**NSLPP MEETING HELD ON 05/06/2024****Attachments:**

ADDRESS: 42 & 42A Milson Road, Cremorne Point**APPLICATION NO:** DA 302/23**PROPOSAL:** Substantial alterations and additions to lower ground, ground level and first floor additions and demolition of garage and replacement with a three bay garage with green roof.**PLANS REF:**

OWNER: Amrit Pal Singh & Harpreet Kaur**APPLICANT:** Amrit Pal Singh**AUTHOR:** Report of Thomas Holman, Senior Assessment Officer**DATE OF REPORT:** 14 May 2024**DATE LODGED:** 17 October 2023**RECOMMENDATION:** Refusal

02 CURRENT PHOTO FROM CREMORNE RESERVE - 2023 scale 1:NTS
 04 PHOTOMONTAGE - FROM CREMORNE RESERVE scale 1:NTS

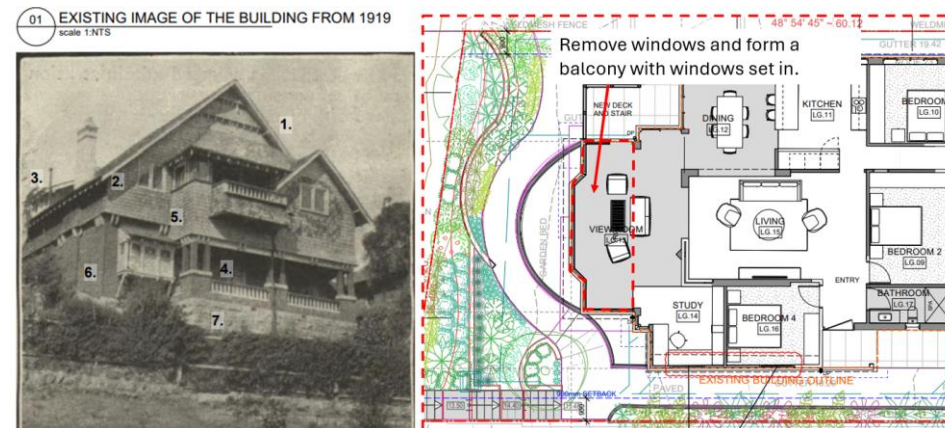
- there are no amendments to improve the lower ground floor glazing with a large glazed window (LG13) proposed not vertically proportioned, multipaned and sympathetic to Federation Arts and Crafts style fenestration. Below is an alternative potential design change discussed with Council's Heritage Officer to address the lower ground floor large glazed window, however it is not the only acceptable heritage outcome.

A potential solution could be to remove the lower ground windows and create a lower ground balcony similar to original building circa 1919.

Figure 29 – Proposed Lower Ground Floor Plan with additions shown in blue

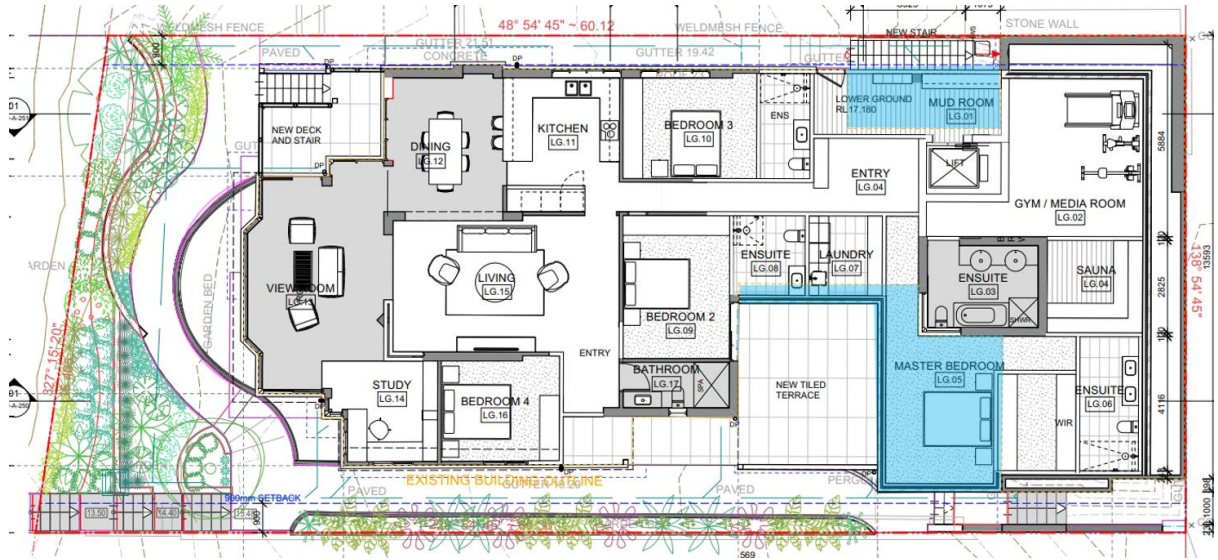
Comment: substantial partitions would remain for the lower ground floor, however more substantial demolition is proposed to the ground level, including demolition of the existing garage and a larger roof form is proposed. Insufficient reasoning is provided that the scope of works is substantially within the fabric of the existing building and a particular challenge the Applicant faces with this subclause is the additional bulk and scale and scope of additions transforming the design and bulk and scale beyond that of the existing building. The subclause restricts the scope of work to more minor alterations and additions compared to that currently proposed therefore the works are deemed not to be substantially within the fabric of the building to satisfy Cl. 6.6(2)(b)(i) of NSLEP 2013.

Below are relevant floor plans detailing the additional footprint beyond the fabric of the existing building and a comparison of the photo of the building versus a render confirming the development increases the bulk and scale of the building not reserving works within the fabric of the existing building.

| | |  <p>Figure 36 – Existing Roof Plan, DA-A-050 Rev G</p>  <p>Figure 37 – Proposed Roof Plan, DA-A-103 Rev H</p> |

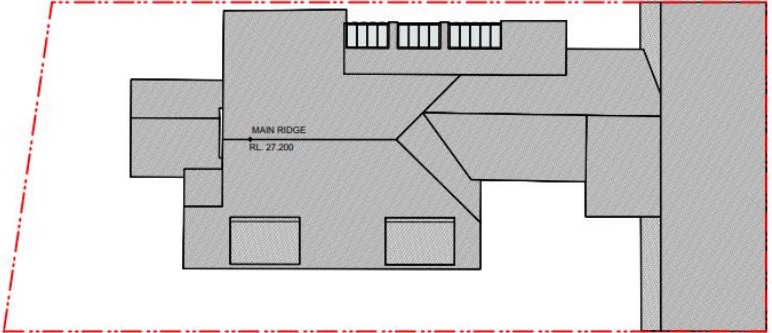
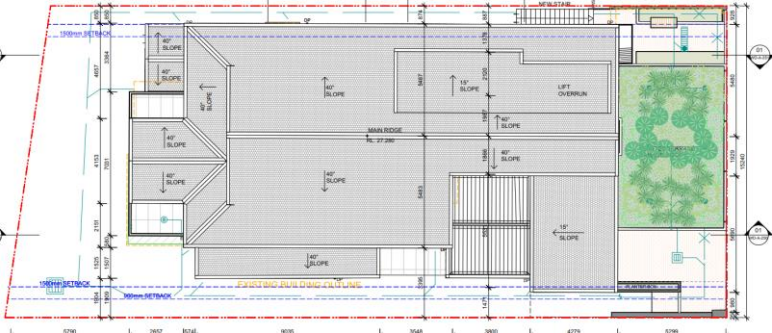
Reference to the existing lower ground floor notes a finished floor level of RL 17.180. The new roof for the dual occupancy would have a ridge height of RL 27.280 therefore it is considered the development measured from the lower ground level ensuite to the proposed roof ridge would have a maximum height of 10.1m which is an exceedance of 18.8%. Below is an annotated plan to try to clarify the discrepancies in the approach to measuring the height of building.

| 1.4.5 Siting | No | <p>The characteristic siting for buildings in the Cremorne Point Conservation Area as stipulated in s6.4.6, Part C of the DCP is to the middle of the lot with gardens to the front and rear.</p> <p>The development comprising of additional building footprint to the front of the lot and a new larger roof form with additional bulk and scale to the front of the site does not uphold the characteristic siting of buildings in the conservation area.</p> <p>Below is an existing roof plan confirming apart from the garage the bulk of the dual occupancy is centrally sited within the site. However, additional site coverage and a larger roof form degrades the existing characteristic siting of the building.</p> |

Figures 43 & 44 – Annotated Calculation Diagram highlighting the garage, covered porch and rear part covered terrace defined as site coverage (left) and Upper Ground Floor Plan showing Garage extending to the front boundary of the site (right)

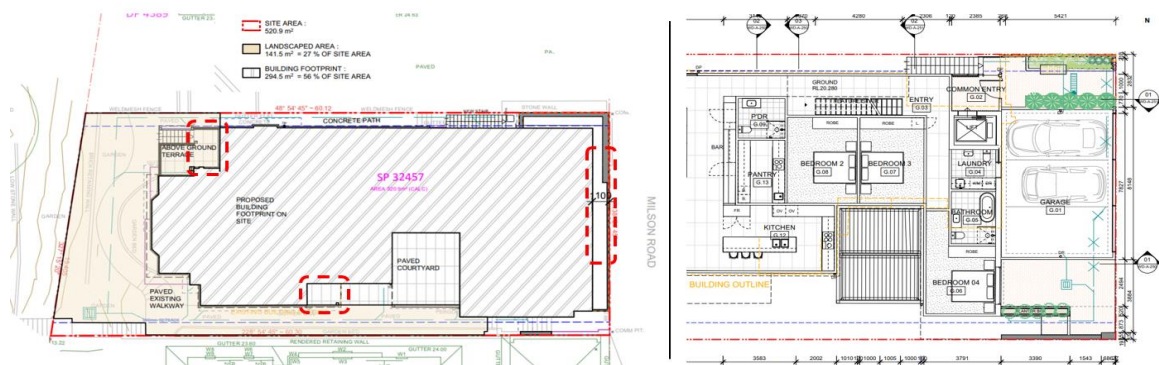
The set of architectural plans includes a Proposed Calculations Diagram (DA-A-022 Rev G) detailing the proposed building footprint (site coverage) and the landscaped area. The proposed calculations diagram does not detail the proposed un-built upon area noting proposed pathways within the setbacks of the site particularly the eastern and southern setback are not accounted for as un-built upon area.

- The **site coverage** shown in DA-A-022 Rev G does not accurately show the full extent of proposed site coverage. the diagram excludes the lower ground floor which constitutes site coverage/building footprint. The additional site coverage from the garage within the front setback also has not been accounted for which would increase the extent of site coverage (annotated below).

Figure 45 – Annotated Calculation Diagram highlighted in purple detailing the areas of paving, paths and uncovered courtyard defined as un-built upon area

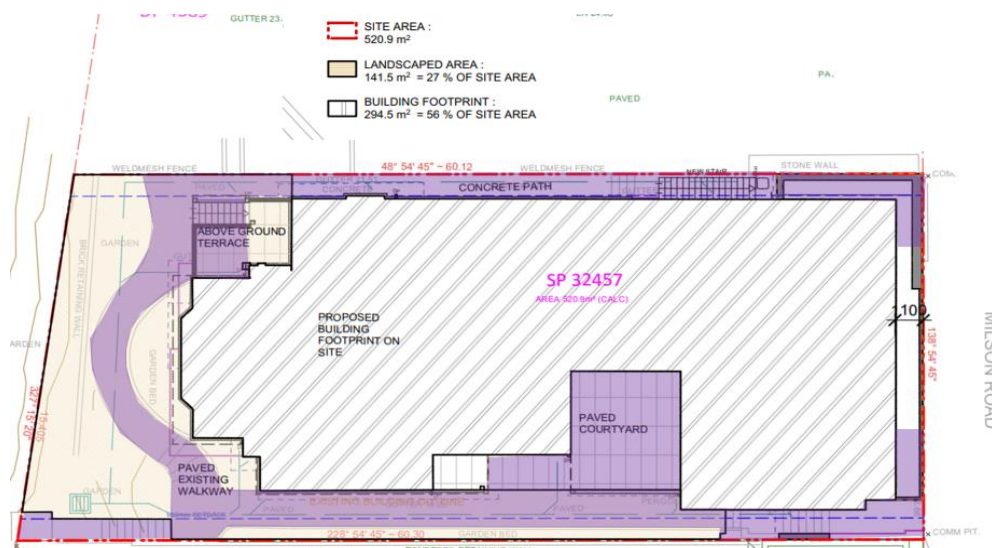
- The Landscaped Area is not properly shown or the un-built upon area as per the definition in Provision P2 in s1.5.6 of NSDCP 2013.

Figures 46 & 47 – Proposed Calculation Diagram, DA-A-405 Rev A (left) and Lower Ground Floor Plan, DA-A-100 I (right)

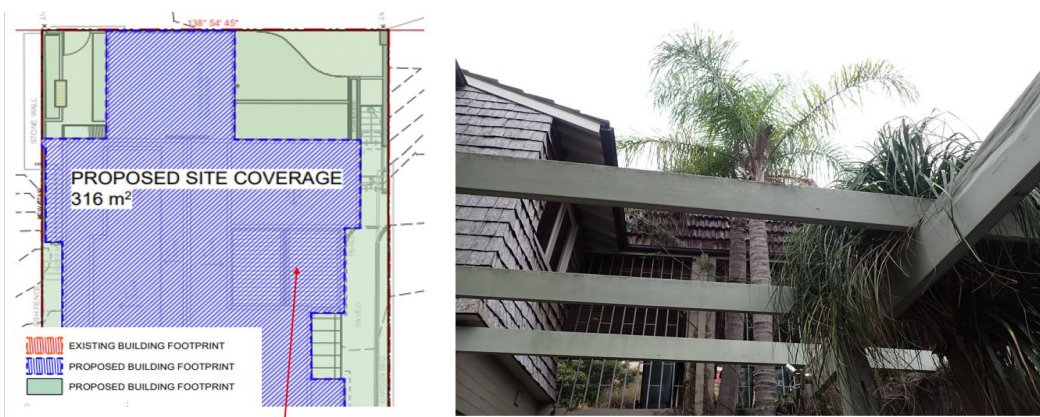
- Site Coverage – the site coverage measures the outline of the dual occupancy roof but does not factor into account the floor footprint of the lower ground floor therefore the site coverage calculation of 316m2 is considered inaccurate.
